TECHNICAL MEMORANDUM REGARDING REVISIONS TO SAMPLE LOCATIONS FOR  
REMEDIAL INVESTIGATION AT OPERABLE UNIT 6 (OU 6) SITE 11 NAS CECIL FIELD FL  
8/4/1995  
ABB ENVIRONMENTAL SERVICES INC

**Subject: Contract No. N62467-89-D-0317, CTO 090  
Technical Memorandum: Revisions to Sample Locations, Operable Unit 6  
(Site 11) Remedial Investigation, NAS Cecil Field Installation Restoration  
Program**

**FIGURE 4-13**  
**PROPOSED SITE 11**  
**SURFACE SOIL, SUBSURFACE SOIL, AND**  
**GROUNDWATER SAMPLING LOCATIONS**

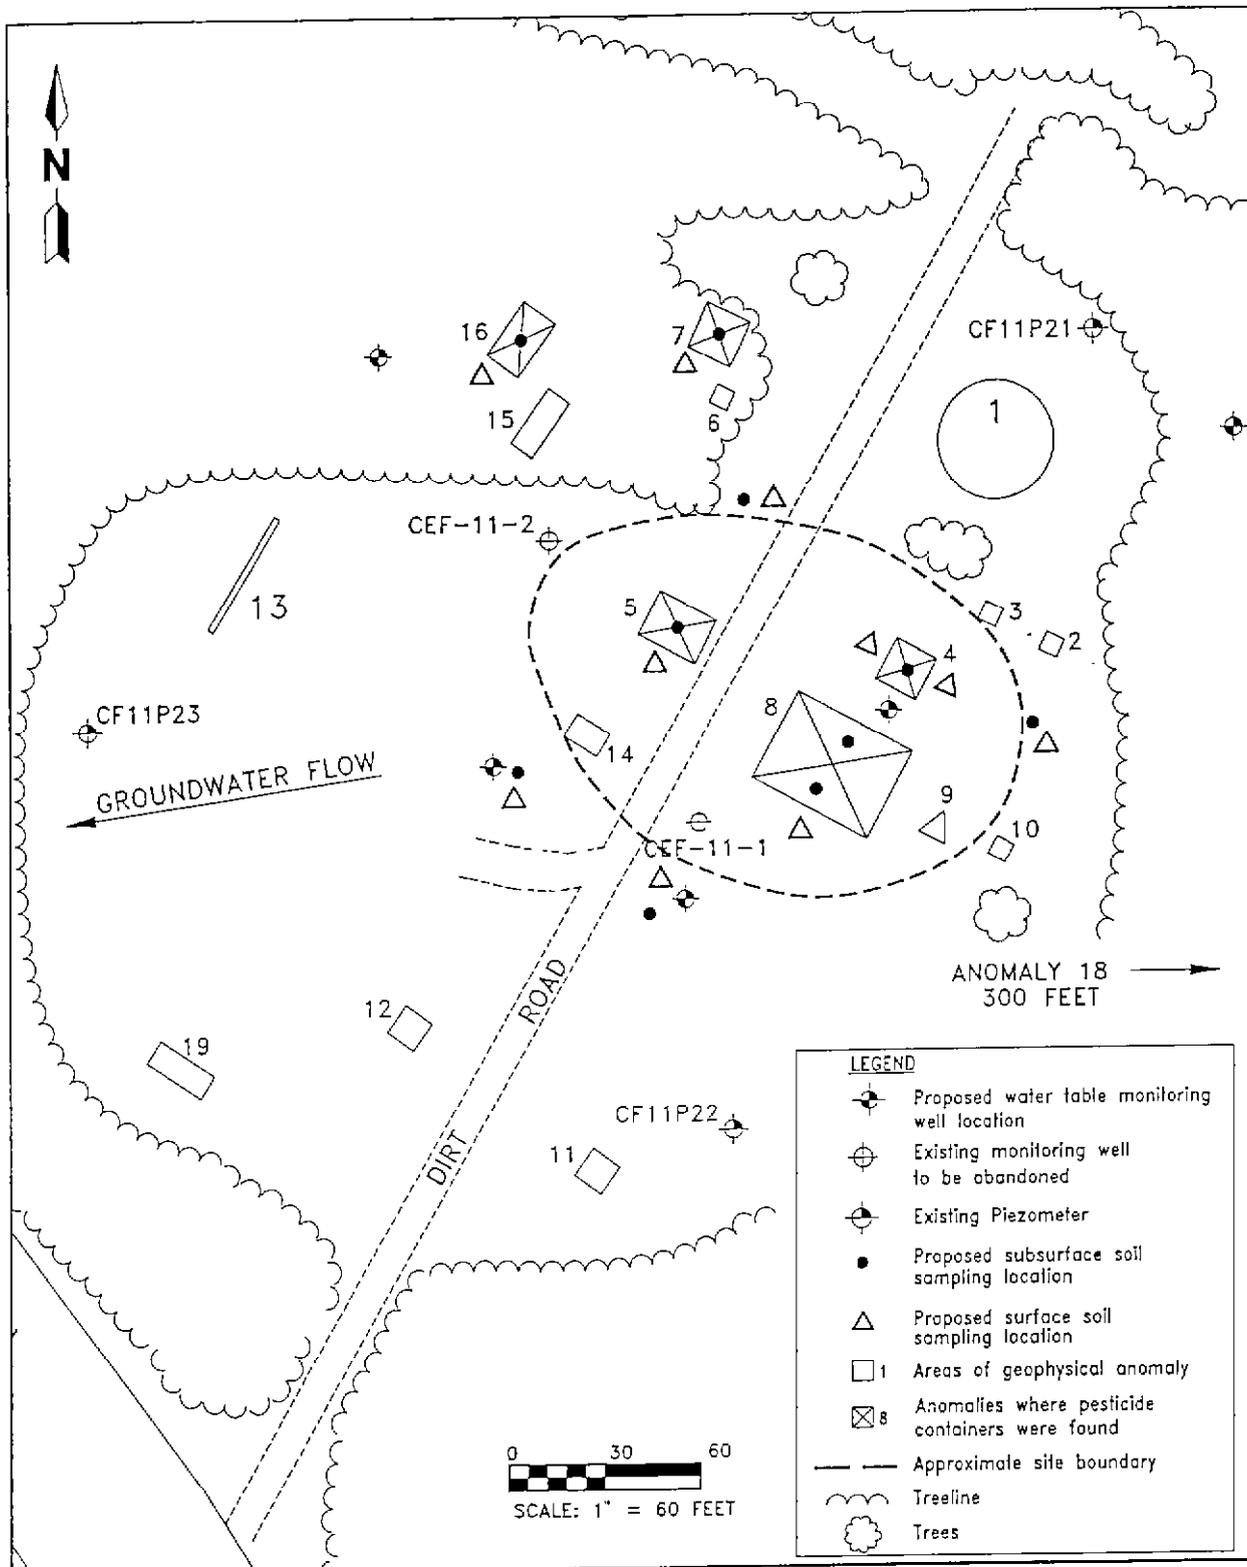
Groundwater - Install five water table monitoring wells: one upgradient, one between anomalies 4 and 8, and three downgradient. Sample groundwater from these wells and analyze for TCL organics,

TAL inorganics, 1,2-dibromo-3-chloropropane, and organophosphorus pesticides. After installation of the five monitoring wells abandon the two existing wells that have 20-foot screens.

The Workplan called for the installation and sampling of four 3-well clusters. Because the contaminant source is being removed and the absence of contamination in general ABB-ES recommends obtaining analytical results from monitoring wells in the surficial aquifer before installing intermediate and deep wells.

Surface Soil - Collect 10 surface soil samples, one near each of the five anomalies and five from the area of investigation. Analyze surface soil samples for TCL organics, TAL inorganics, 1,2-dibromo-3-chloropropane, and organophosphorus pesticides.

The Workplan called for the collection and analysis of 38 surface soil samples, one from each of the 19 anomalies and 19 from the areas between the anomalies. Since there were no pesticide containers at 14 of the anomalies, and a limited amount of contaminants were found in the anomalies that contained pesticide containers, it is not necessary to sample the 14 anomalies that did not contain pesticide containers or the areas between them.

Subsurface Soil - Collect 10 subsurface soil samples, one each from anomalies 4,5,7, and 16, two from anomaly 8, and four from within the historical site boundary. Analyze subsurface soil samples for TCL organics, TAL inorganics, 1,2-dibromo-3-chloropropane, and organophosphorus pesticides.

The Workplan called for the collection and analyses of 19 subsurface soil samples. One from each of the nineteen anomalies. Since there were no pesticide containers at 14 of the anomalies it is not necessary to sample them.
